Re: Endangered Species Act Section 7 Informal Consultation and Magnuson-Stevens Fishery Conservation and Management Act Essential Fish Habitat Consultation for the Port of Siuslaw Interpretive Wayside, Siuslaw River (HUC: 171002060804 Bernhardt Creek), Lane County, Oregon

This letter is submitted as part of the Community Development Department's review of your application for a conditional use permit and design review for the Siuslaw Interpretive Wayside located under the Siuslaw Bridge and at 1250 Bay Street, Map # 18-12-34-14 T/L 700, 101, and 107. Specifically, staff looked at the submitted documents and reviewed them for completeness in order to process the land use application. Staff also looked at the application to help you prepare for the public hearing as the Planning Commissioners have been emphasizing the need for complete applications. During the review, staff found that there are some items that are needed to make the application complete. The following text includes items to make the application complete, items which will clarify submitted information, and a discrepancy list.

Thank you for the thorough review of the subject project land use applications. The purpose

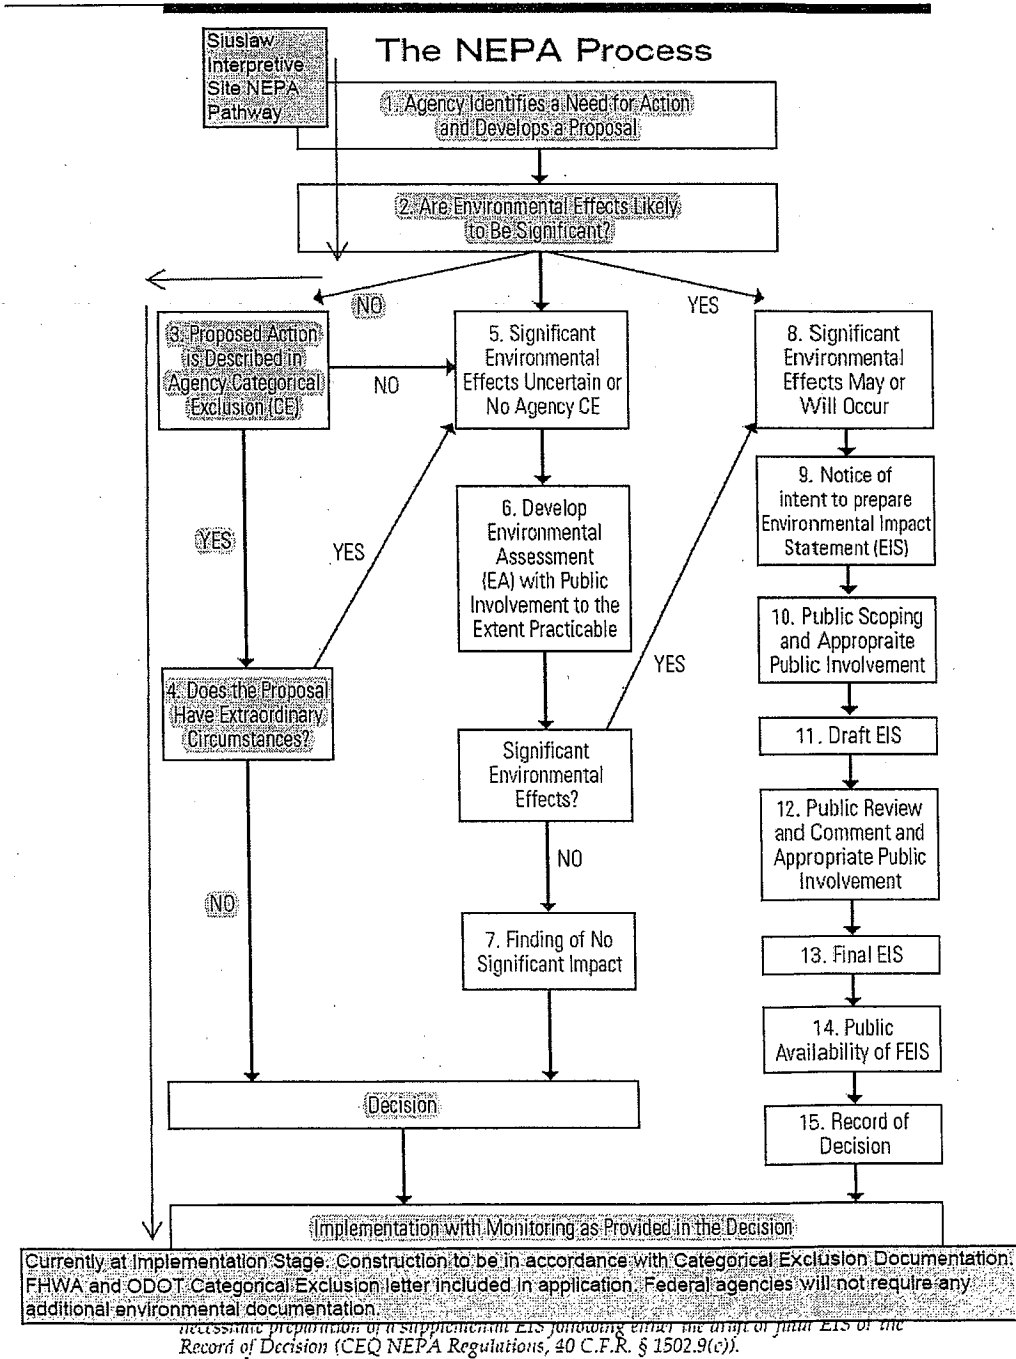
2. Riprap Elevations: The narrative states that riprap will be added to the Wayside West. Sheet C6 (sheet 6 of 13) shows where the outfall protection will be on the Wayside East and provides an elevation of how the rocks will be placed. The drawings do not include riprap for Wayside West. Provide a similar drawing of sheet C6 (sheet 6 of 13) for Wayside West riprap.

See attached.
